**Independent Design Peer Review**

# CROWN STREET, SURRY HILLS DEVONSHIRE ST TO OXFORD ST UPGRADE PEER REVIEW

CITY OF SYDNEY  
MARCH 2023  
FINAL

STATUS	FINAL
ISSUE	D
DATE	03,03,2023
PREPARED BY	GJ/ZY
APPROVED BY	JP

### Review of existing concept design

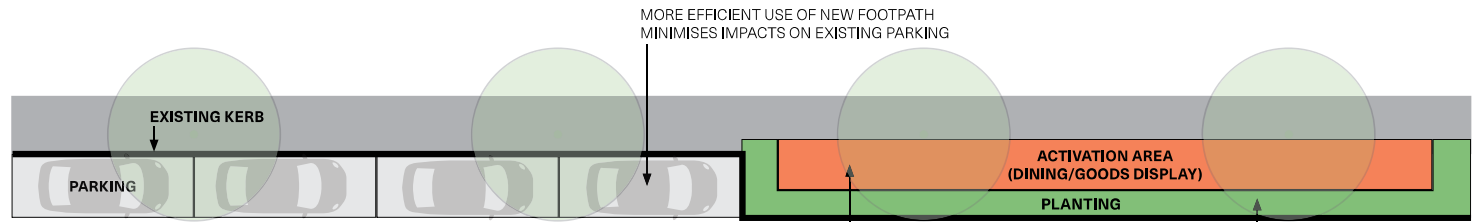
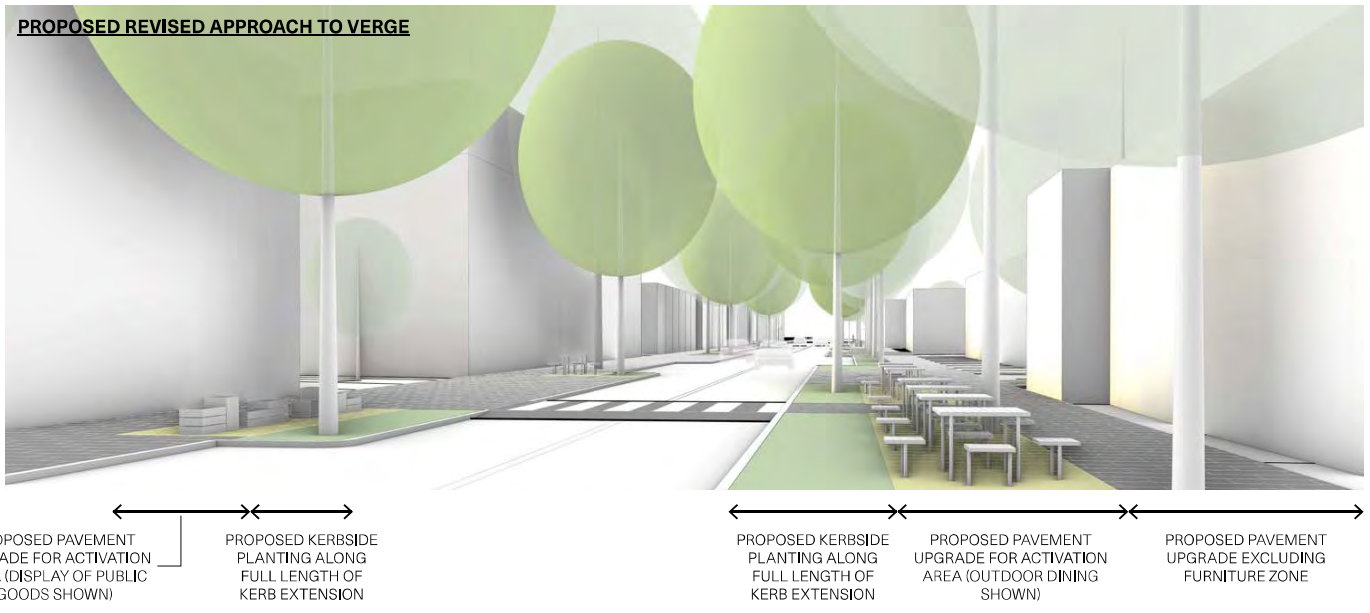
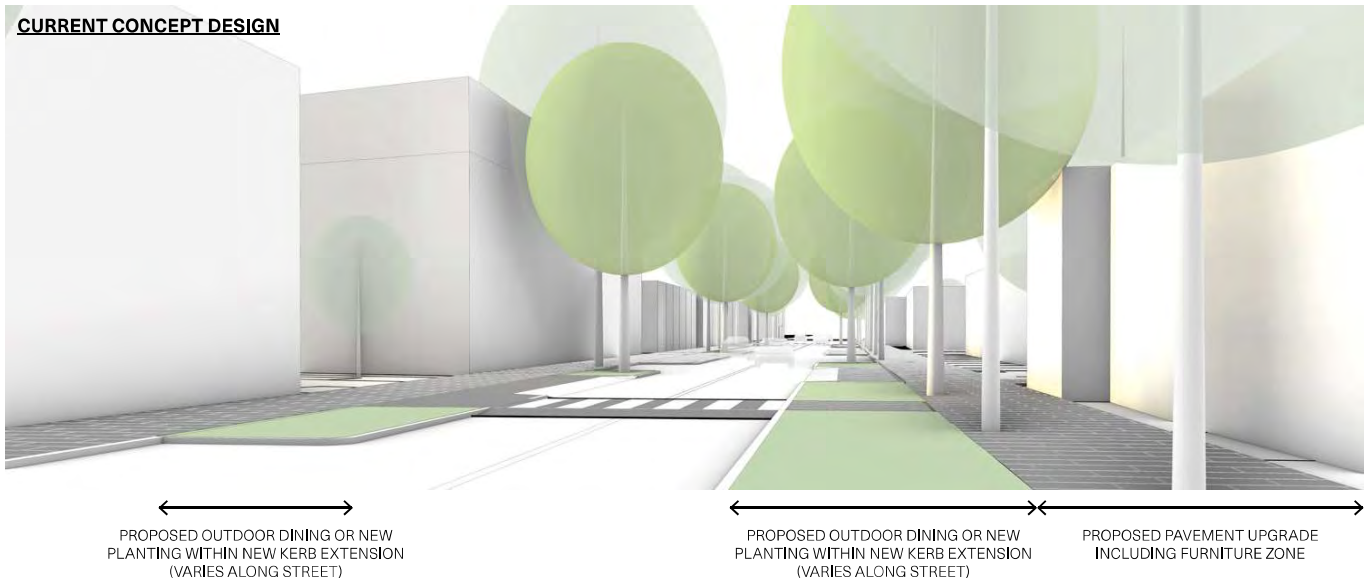
The current concept design proposes a significant gain in public space within the verge - the result of kerb extensions and lane narrowing along much of Crown Street.

The resulting public domain design proposes a binary approach to the design of this additional public space, creating large areas of outdoor dining interspersed with large areas of planting, both of which occupy the full width of the proposed kerb extension.

We believe there is an opportunity to adopt an alternate arrangement to public domain in the verge that:

- Provides more opportunities for greening and tree planting
- Creates flexible areas of pedestrian paving—what we call Activation Areas—that can be used for outdoor dining, displaying goods, or other opportunities that the local and business community may develop over time
- Provides buffer planting between Activation Areas and moving vehicular traffic in adjacent travel lanes
- Provides an efficient use of verge space that allows for reducing impacts on existing car parking supply.

MORE EFFICIENT USE OF NEW FOOTPATH  
MINIMISES IMPACTS ON EXISTING PARKING

ACTIVATION AREA SETBACK  
FROM KERB

CREATES LONGER FLEXIBLE  
ACTIVATION AREAS FOR  
OUTDOOR DINING AND  
DISPLAYING GOODS

PROVIDES MORE  
OPPORTUNITIES FOR  
GREENING AND TREE  
PLANTING

## Crown Street Peer Review Plan 1 of 8

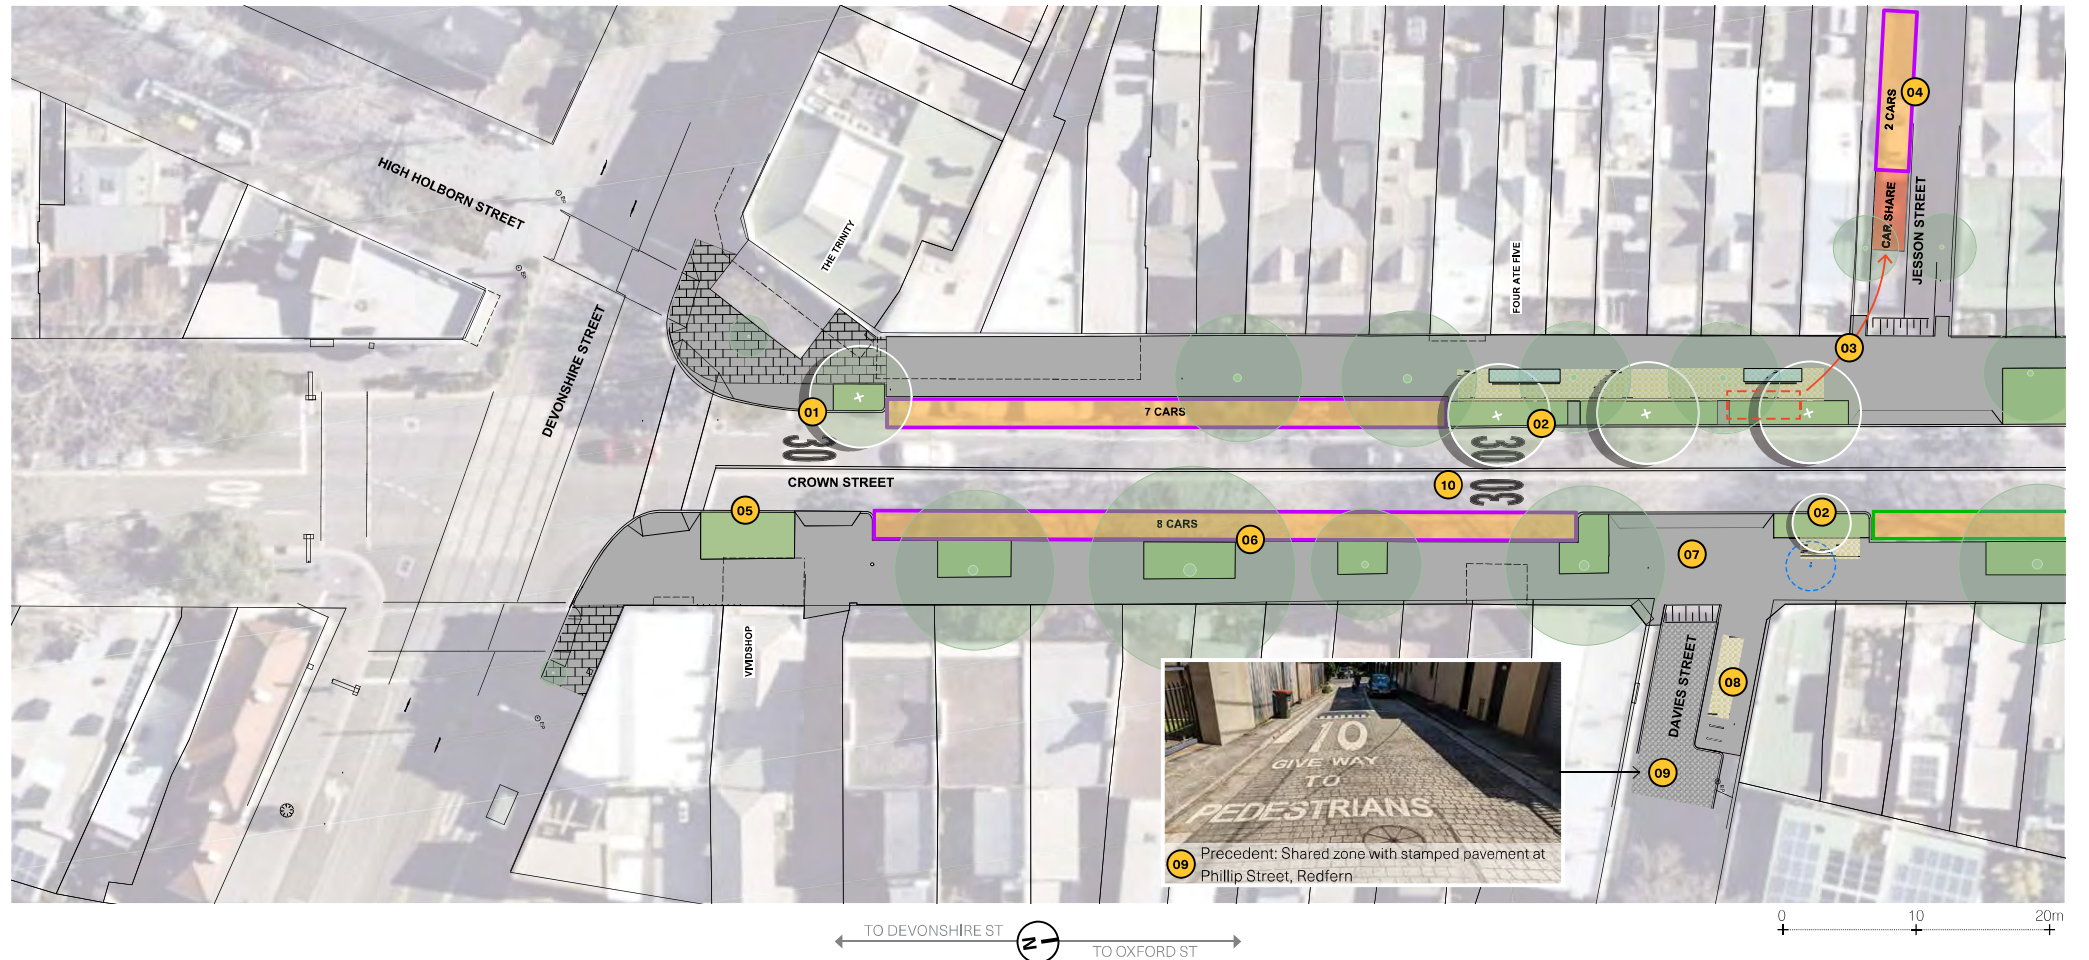
1. Kerb extension and new street tree as per AECOM concept design.
2. New kerb extension to create activation area with kerbside planting and additional street trees at existing commercial premises.

3. Relocate 1 no. existing car share parking space to Jesson St.
4. Convert 2-3 no. existing unmarked 2P parking spaces on Jesson St to 2 no. marked 2P parking spaces.

5. Kerb extension to provide additional pedestrian paving and planting at intersection, with operations to intersection to remain unchanged (subject to TfNSW approval).

6. Kerb alignment adjusted (to minimum compliant parking space width) to maximise footpath and planting space. Increased planting beds to base of existing trees.

7. Continuous footpath treatment and kerb extension at Davies St.
8. Kerb extension to Davies St to provide additional activation area and space for new bike parking.

9. New shared zone with stamped pavement to Davies St, to be consistent with other typical City of Sydney laneway shared zones (subject to further investigation and TfNSW approval).

10. Speed reduction to Crown Street to 30km/h (subject to TfNSW approval).

### Crown Street Peer Review Plan 2 of 8

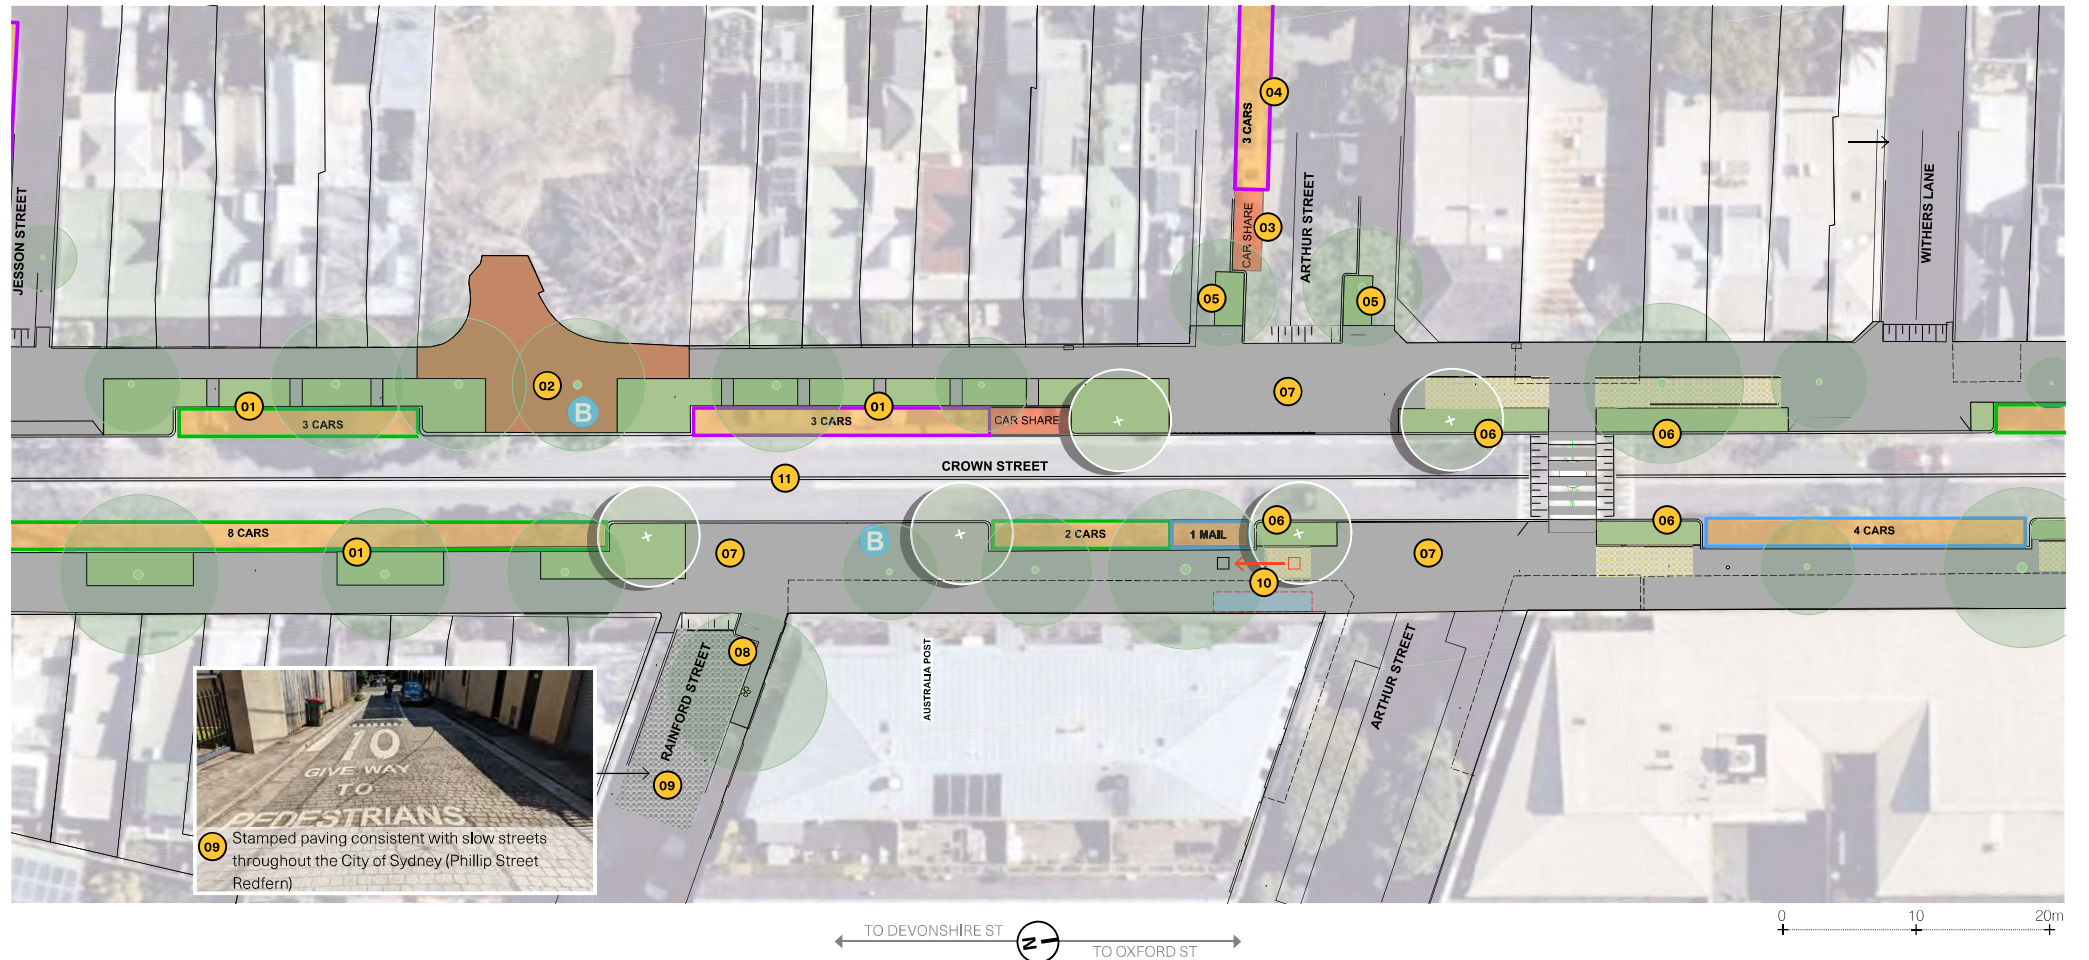
1. Kerb alignment adjusted (to minimum compliant parking space width) to maximise footpath and planting space. Continuous planting bed provided with intermittent pavements for access to parked vehicles.

2. Bus stop 'in the park' - in-lane bus stop located to align with Tudor St park, with existing brick paving to full width of Tudor St lot boundary to be retained.

3. Relocate 1 no. existing car share parking space from outside The Clock Hotel to Arthur St.
4. Convert 4 no. existing unmarked 2P parking spaces on Arthur St to 3 no. marked 2P parking spaces.

5. Kerb extensions to Arthur St to provide additional space for planting and bike parking, and lane narrowing for traffic calming.
6. New kerb extension to create activation area with kerbside planting, and additional street trees at existing commercial premises.

7. Continuous footpath treatment and kerb extension where side streets.
8. Kerb extension to Rainford St to provide additional space for new bike parking.

9. New shared zone with stamped pavement to Rainford St, to be consistent with other typical City of Sydney laneway shared zones (subject to further investigation and TfNSW approval).

10. Minor relocation of existing mail box to provide additional activation area.
11. Speed reduction to Crown Street to 30km/h (subject to TfNSW approval).

### Crown Street Peer Review Plan 3 of 8

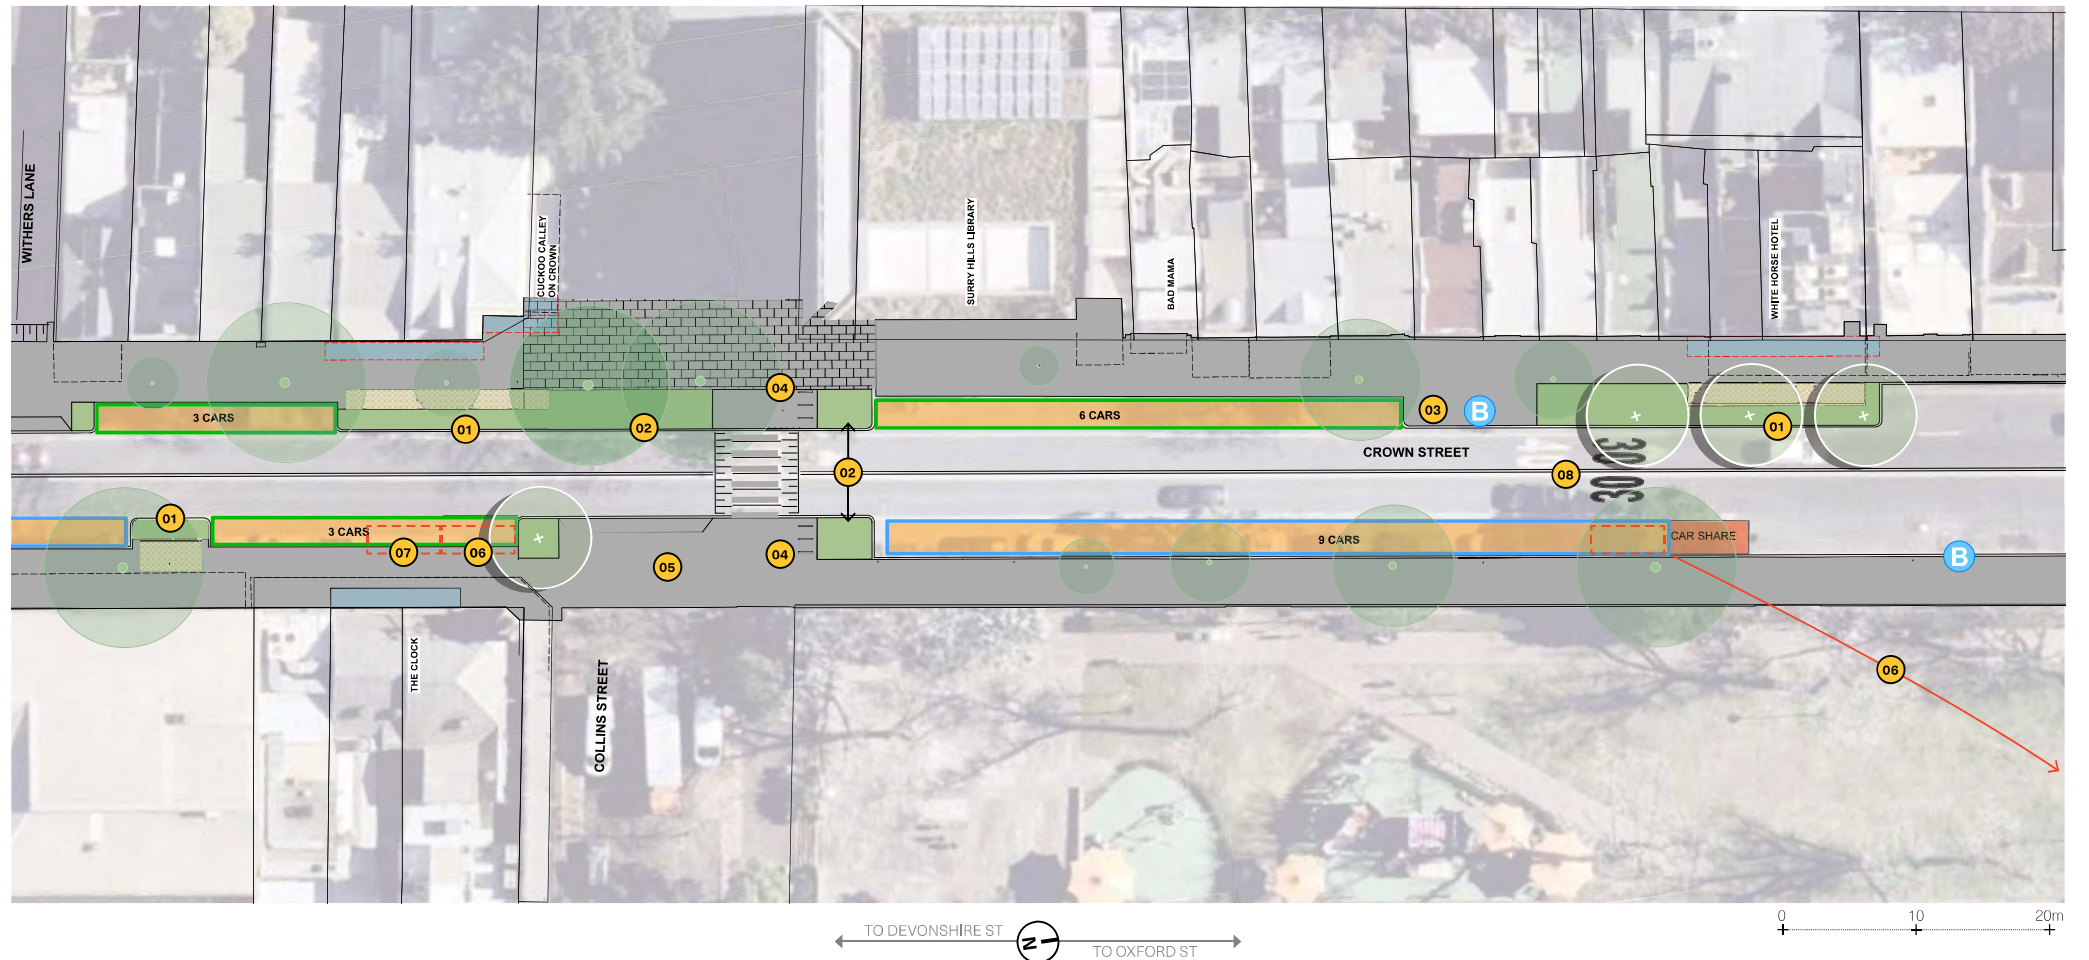
1. New kerb extension to create activation area with kerbside planting, and additional street trees at existing commercial premises.
2. New kerb extensions with additional planting (assess amenity and performance of raingarden application in main street with potential to replace with street planting consistent with approved planting palette).
3. New kerb extension for in-lane bus stop, 9m paving zone shown (to be reviewed at detailed design stage to consider user access requirements).
4. New bike parking a key arrival point to Crown St and point of dismount for cyclists approach via Crown St or Collins St.
5. Continuous footpath treatment and kerb extension at Collins St.
6. Relocate 2 no. existing car share parking spaces to Richards Ln.
7. Relocate 1 no. existing car share parking spaces to Arthur St.
8. Speed reduction to Crown Street to 30km/h (subject to TfNSW approval).
